RE: **Initial Submission Review** – Windler Tibet Road – Site Plan Amendment
Case Number: 2022-6011-01

WINDLER
TIBET ROAD/SP
42ND AVENUE TO 48TH AVENUE
HORIZONTAL AND VERTICAL CONTROL

WINDLER
TIBET ROAD ISP
42ND AVENUE TO 48TH AVENUE
ROADWAY PLAN

SHEET NUMBER	DRAWN BY:	CHECKED BY:	DATE:	SCALE:	AS SHOWN	FILE NO:	Revisions	Date	Appr.	Date
							No.			
11										
OF 17

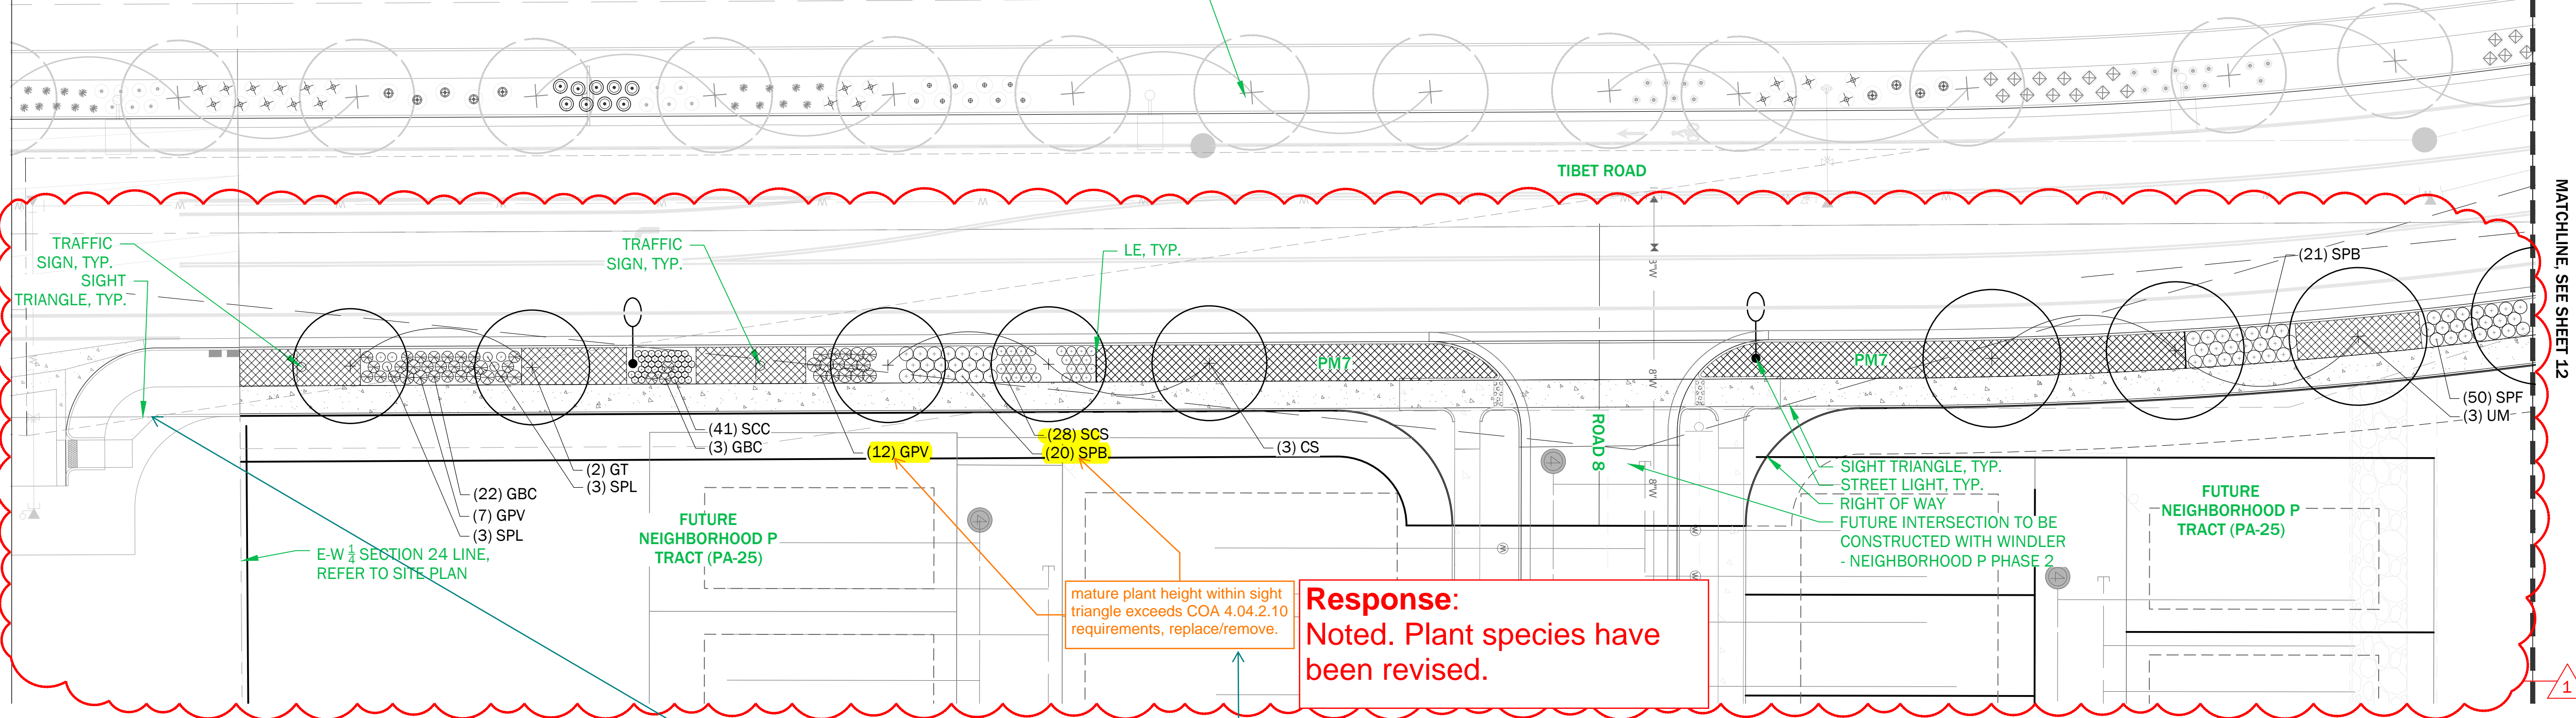
- Please confirm that the proposed landscaping will meet Sec. 4.2.3.(I)(2), which states that no landscaping shall obstruct any sight visibility above the sight triangle area for more than six horizontal inches between height of 26 inches and 96 inches above the roadway surface. Trees with an expected mature diameter at Breast Height (DBH) of six inches or less may be planted and maintained within the sight triangle area if all branches are trimmed to maintain a clear vision for a vertical height of 96 inches above the roadway surface. If necessary, please remove replace any plantings that do not comply with the above standard.

- Please note that the mature plant height within sight triangle exceeds COA 4.04.2.10 requirements, replace/remove as necessary.

mature plant height within sight
triangle exceeds COA 4.04.2.10
requirements, replace/remove.

Please confirm that the proposed landscaping will meet Sec. 4.2.3. (l)(2), which states that no landscaping shall obstruct any sight visibility above the sight triangle area for more than six horizontal inches between a height of 26 inches and 96 inches above the roadway surface. Trees with an expected mature Diameter at Breast Height (DBH) of six inches or less may be planted and maintained within the sight triangle area if all branches are trimmed to maintain a clear vision for a vertical height of 96 inches above the roadway surface.

Response: Noted. Proposing landscaping shall meet the requirements of the City of Aurora's Unified Development Ordinance Section 4.23.i.2 requirement, instead of COA Roadway Design Manual Section 4.04.2.10..

***Response:** Noted. Plant species have been revised.*

Response:
Noted. Plant species have
been revised.

Response:
Noted. Proposed landscaping shall meet the requirements of the City of Aurora's Unified Development Ordinance Section 4.2.3.i.2. Note on Sheet 16 has been updated to reflect UDO Section 4.2.3.i.2 requirement, instead of COA Roadway Design Manual Section 4.04.2.10.

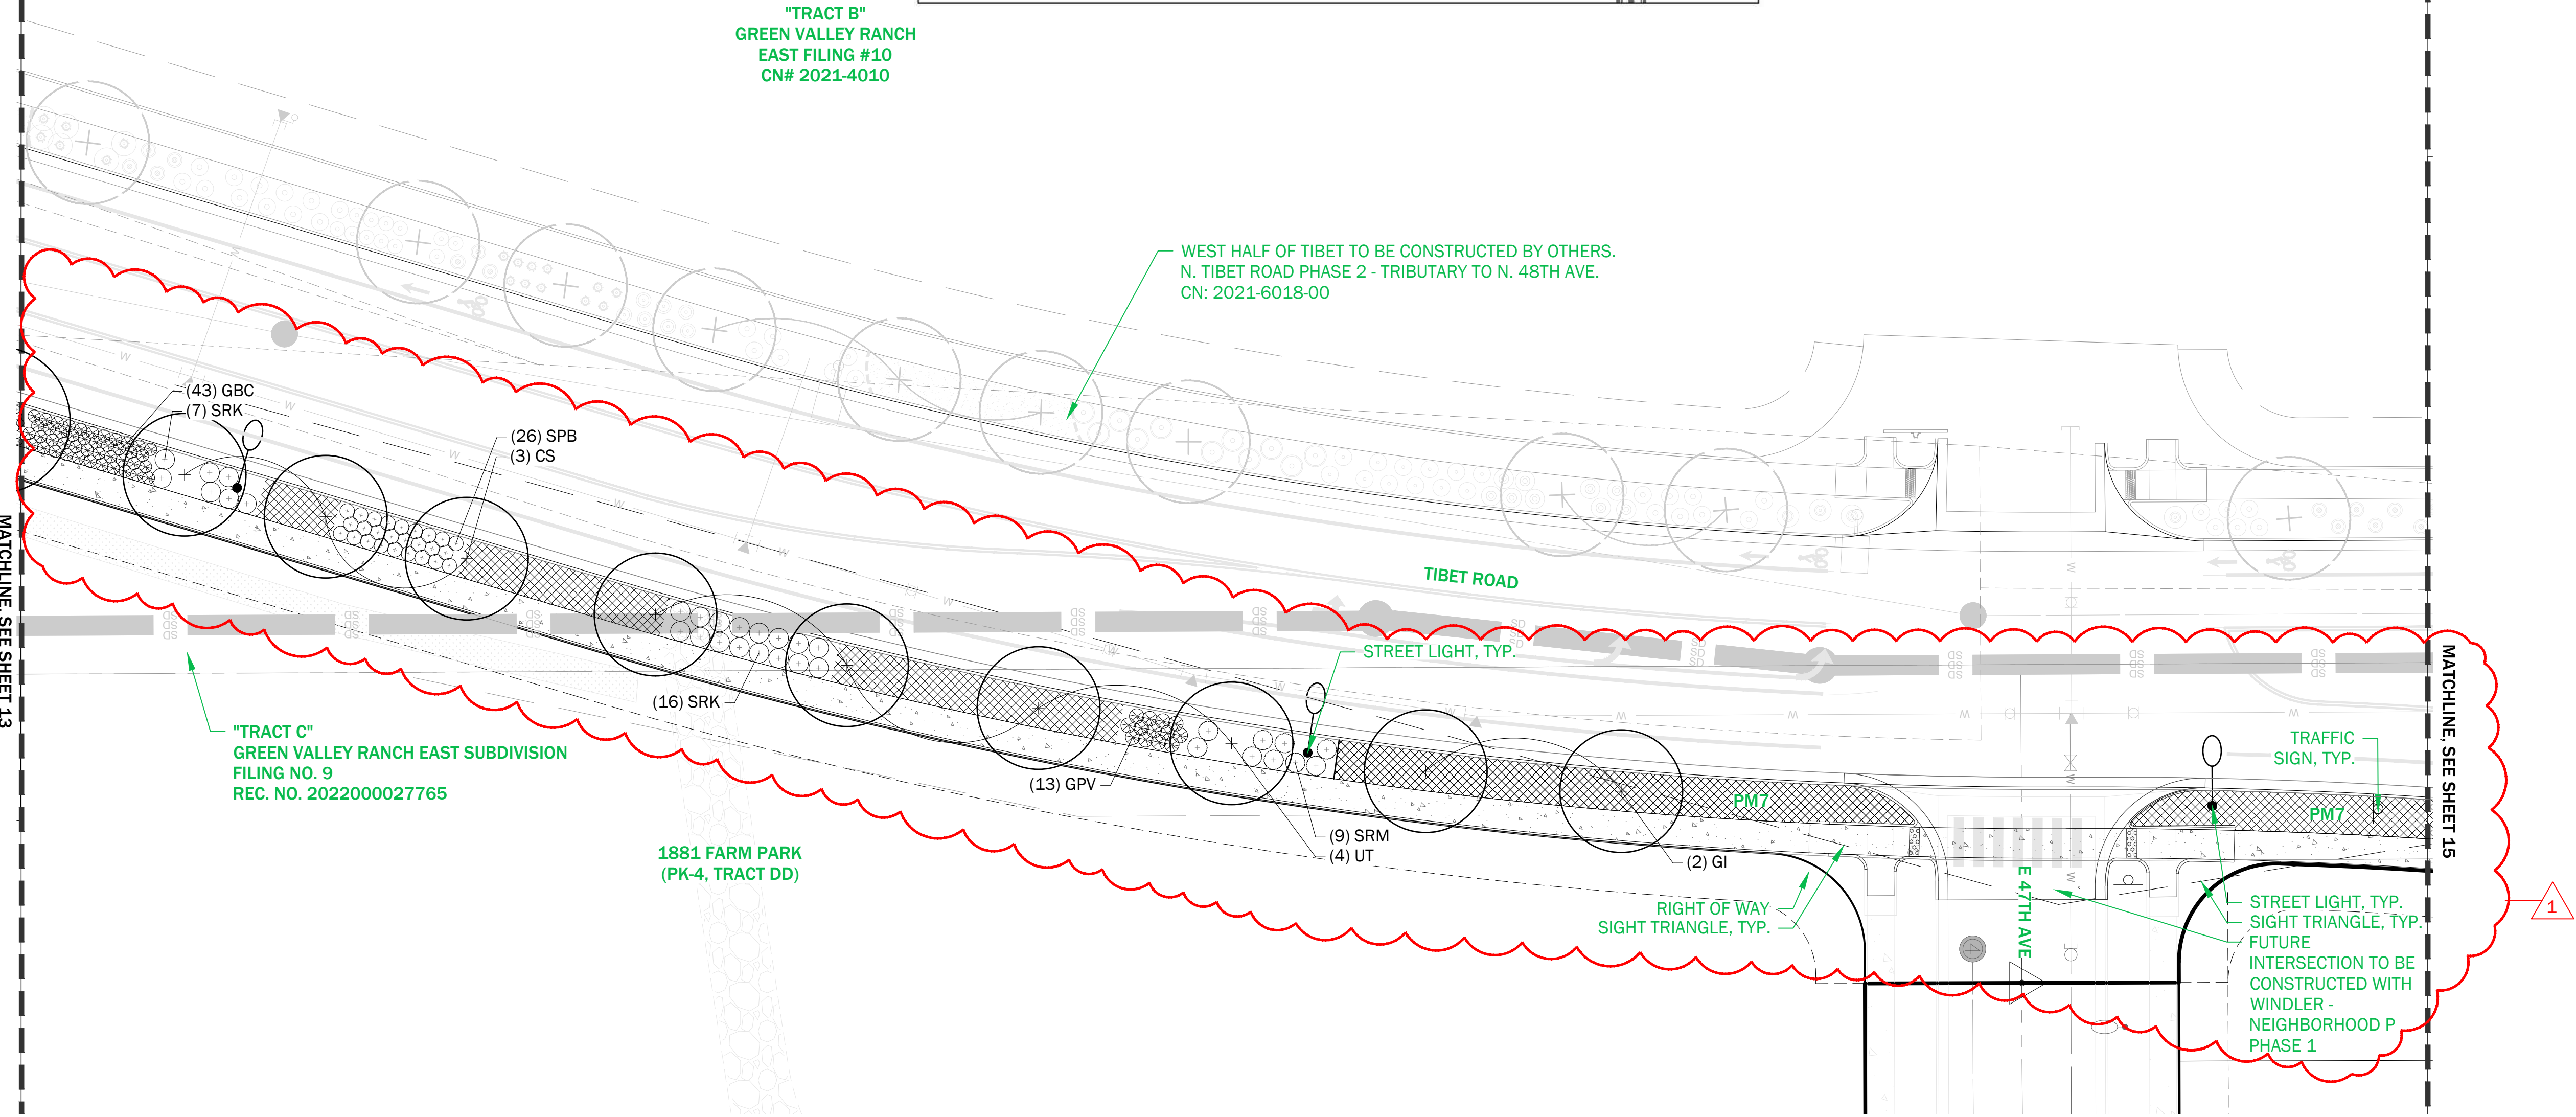
- Please show the sight triangle and verify that the mature plant height within the sight triangle meets COA 4.04.2.10 requirements and replace. remove as necessary.

- Please move stop sign closer to ped ramp.

show sight triangle and verify mature plant height within sight meets COA 4.04.2.10 requirements, replace/remove as necessary.

***Response:** Noted. Sight triangle label has been adjusted and plant species have been revised.*

***Response:** Stop sign has been relocated closer to ramp. Please note that stop sign is for interim condition prior to final buildout and signalization, while sight triangle labeled is based on final buildout.*

Response:
Noted. Sight triangle label
has been adjusted and plant
species have been revised.

Response:
Stop sign has been relocated
closer to pedestrian ramp.
